Staff Report
City of Richmond, Virginia
Commission of Architectural Review

1. COA-111519-2022	Final Review	Meeting Date: 5/24/2022
Applicant/Petitioner	Anne Grier	
Project Description	Replace an existing rear aluminum fence with a stucco clad masonry wall and metal gate.	
Project Location		
Address: 3317 Monument Ave.		
Historic District: Monument Avenue		
High-Level Details: <p>The Applicant proposes to replace an existing black, aluminum rear fence with a 6-foot wall clad in stucco.</p> <p>The stucco color will be “sand” and the texture will match the stucco on the main dwelling’s rear addition, which was constructed in 2015</p> <p>The stucco clad wall will have two black aluminum gates with minimal ornamentation.</p>		
Staff Recommendation	Approval, with Conditions	
Staff Contact	Alex Dandridge, alex.dandridge@rva.gov , (804) 646-6569	
Previous Reviews	In 2015, the Commission approved the construction of a rear addition to the main dwelling.	
Conditions for Approval	<ul style="list-style-type: none"> Staff recommends that the final gate design not include decorative elements, but rather be a simple design, similar to the existing gates, specifications be submitted to staff for

Figure 3. Existing rear aluminum fence. CAR Files, Feb. 2019

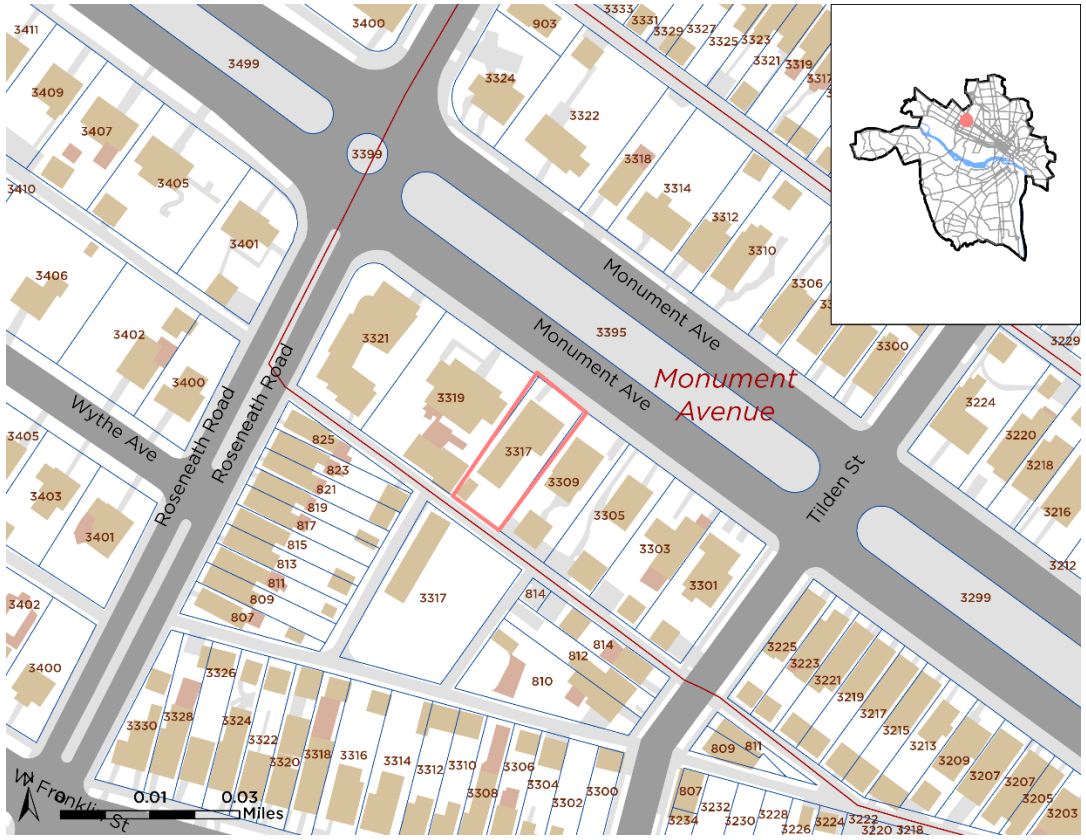
Guideline Reference	Reference Text	Analysis
Standards For Site improvements,	5. When considering the design of new fences, remember that some districts, such as Church Hill North and Union Hill,	The applicant is proposing to replace an existing black, aluminum, rear fence with a stucco clad wall, which will be a simple design

<p>Fences, pg. 5, 6 & 9</p>	<p>historically featured modest wooden picket fences, while some districts, such as Monument Avenue and West Grace Street, more rarely had fences, and when they did occur, were rarely wooden picket fences. In the event of a conjectural fence, the design should seek simplicity, rather than elaboration.</p> <p>6. A new fence or wall should be constructed using materials and designs appropriate to the District. Height restrictions are governed by the Zoning Ordinance.</p> <p>9. Rear-yard privacy fences should mimic traditional fence designs.</p>	<p>and feature materials that are common in the district and present on the existing dwelling.</p> <p>The wall will extend along the side and rear property lines, and will be six feet tall and consist of ten foot wide wall sections divided by vertical pillars with 12x12" limestone caps.</p> <p>There are many examples of rear wall throughout the Monument Avenue City Old and Historic District, mostly brick, however stucco examples, while not as common, are present.</p> <p>There will be two, black, aluminum gates associated with the wall. The gates will be a simple design with vertical pickets and decorative pointed caps. <u>Staff recommends that the final gate design not include decorative elements, but rather be a simple design, similar to the existing gates. specifications be submitted to staff for review and approval.</u></p>
